344
Tech Tip

COMPRESSOR SHAFT NUT ELIMINATION

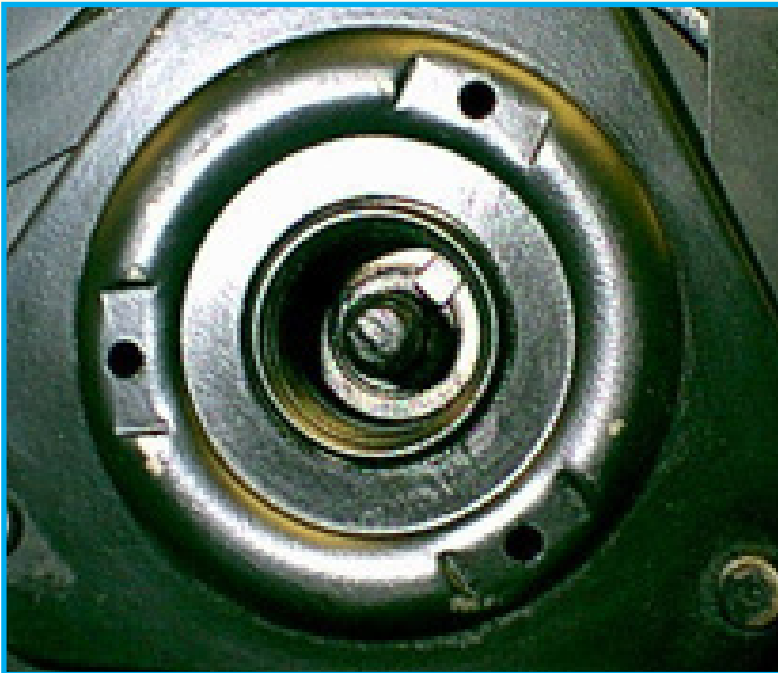
Through years of quality machining and manufacturing, it has become possible to eliminate the shaft nut on new Delphi-Harrison compressors. Improvements of the press fit between the clutch hub and compressor shaft has enabled OE manufacturers to **NO LONGER REQUIRE** the use or installation of a compressor shaft nut.

Should you receive a Delphi Harrison (GM) type compressor without the shaft nut, **DO NOT** attempt to install one. Attempting to install a nut on the shaft could alter the compressor clutch air gap.

To turn the hub, for testing or as part of the installation procedure, the use of a spanner tool is recommended.
